STATE OF DELAWARE  
EXECUTIVE DEPARTMENT  
OFFICE OF MANAGEMENT AND BUDGET  
Budget Development, Planning and Administration  
State Planning Coordination

RE: PLUS review – 2009-01-01; Stonington

Thank you for meeting with State agency planners on February 2, 2009 to discuss the proposed plans for the Stonington Mixed Use project to be located south of Lynnbury Woods Road, approximately 1,000 feet west of the intersection with Messina Hill Road.

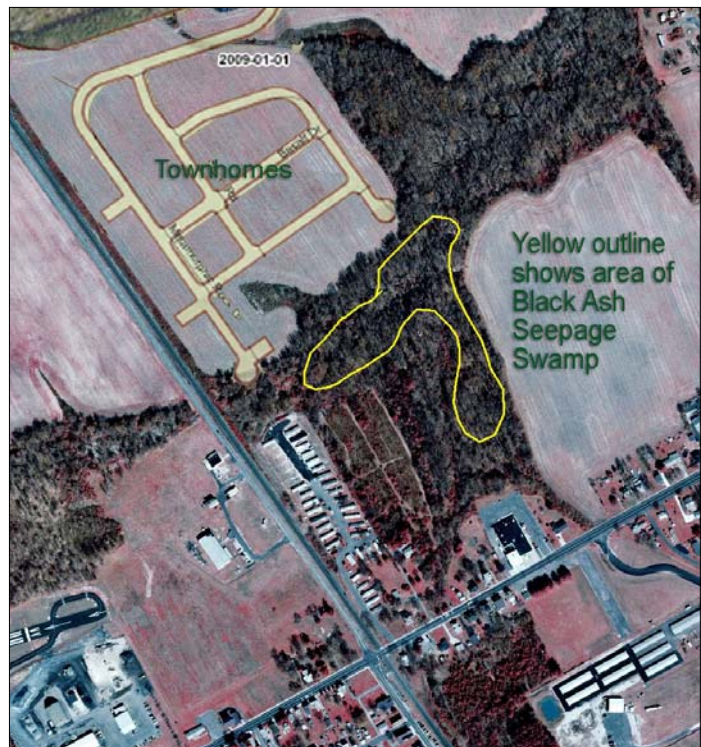
- In the area across from a Black Ash Seepage Swamp containing rare species (see map below), DNREC recommends a 100-foot buffer. There should be no lot lines or infrastructure within this buffer zone.

**Rare species.** According to the Fish and Wildlife database there are 12 rare plants within a Black Ash Seepage Swamp community along Alston Branch. This plant community was nearly destroyed by land clearing activities for another development. These rare plants still persist but the habitat is severely degraded and has not recovered from the disturbance. The current plan indicates that wetland buffers are 50 feet in width. DNREC recommends the applicant consider increasing the buffer to 100 feet in order to protect the rare plant community and water quality within the stream system. Redesigning the site or omitting lots and infrastructure within 100 feet of wetlands would be necessary to achieve this goal. Forested areas along water courses are used by wildlife for feeding, breeding, resting and as a travel corridor linking habitat. There should not be lot lines or infrastructure within this buffer zone and it should be placed in permanent conservation so that future clearing is less likely to occur.

**Figure 1: NRCS soil survey update mapping in the vicinity of the Stonington mixed use plan development.**

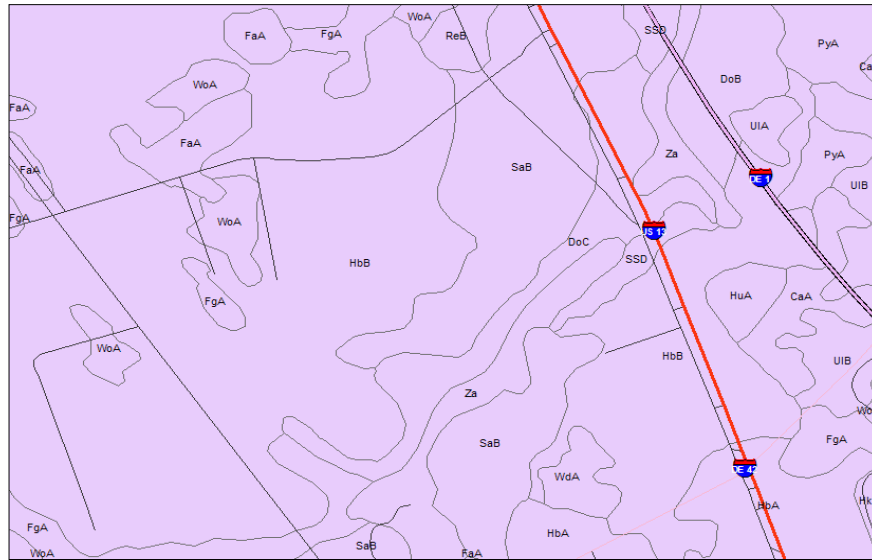
**Soils.** According to the NRCS soil survey update Sassafras (SaB, 2-5% slopes), Downer (DoC, 5-10% slopes), Hambrook (HbB, 2-5% slopes), Fallsington (FgA), and Zakiah were mapped on subject parcel(s). Sassafras, Downer, and Hambrook are well drained uplands soils that, generally, have few limitations for development. Fallsington and Zakiah are poorly to very poorly drained soils (hydric) associated with wetlands, and should be avoided (Figure 1).

**Figure 2: SWMP mapping in the immediate vicinity of the Stonington mixed use development.**

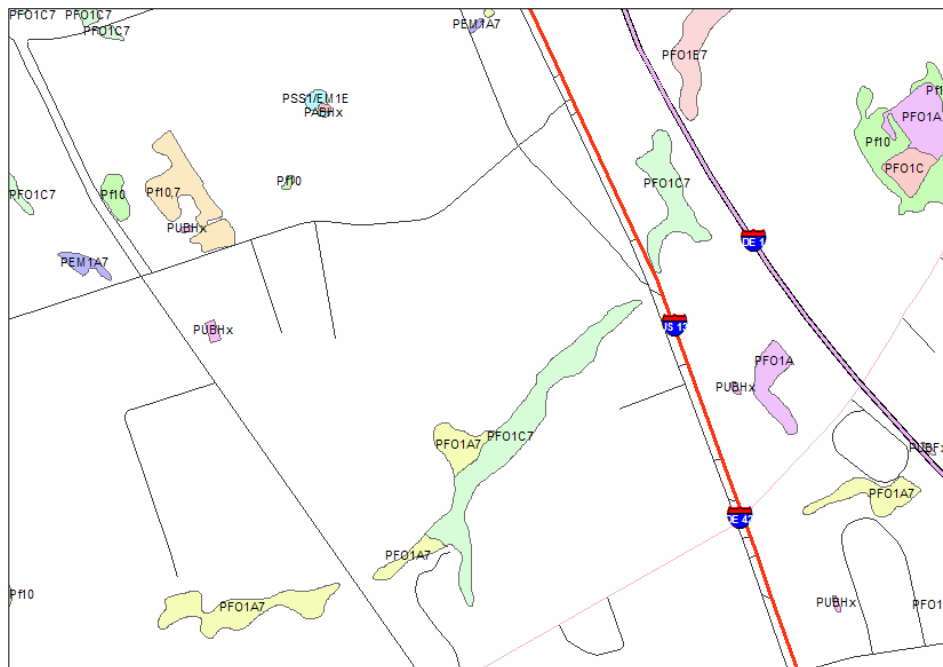
**Wetlands.** According to the Statewide Wetland Mapping Project (SWMP) mapping, palustrine riparian wetlands (PF01A7 & C7). (See figure 2).

Palustrine headwater water riparian wetlands associated with the Alston Branch tributary bound much of the southern boundary of the proposed project area. Headwater riparian wetlands serve to protect water quality which helps maintain the ecological integrity and functions throughout the length of the stream, including the floodplain system and/or water bodies further downstream. Since headwater riparian wetlands serve as natural buffers that protect the water and habitat quality of streams from sediment and nutrient-

laden runoff, their protection deserves the highest priority. Therefore, the Watershed Assessment Section strongly recommends that a 100-foot upland buffer be maintained or established from all of the riparian wetlands bounding Alston Branch. A literature review of existing buffer research by Castelle et al. (1994) has documented consensus among researchers that a 100-foot upland buffer is the minimum buffer width necessary-under most circumstances - to protect water quality.
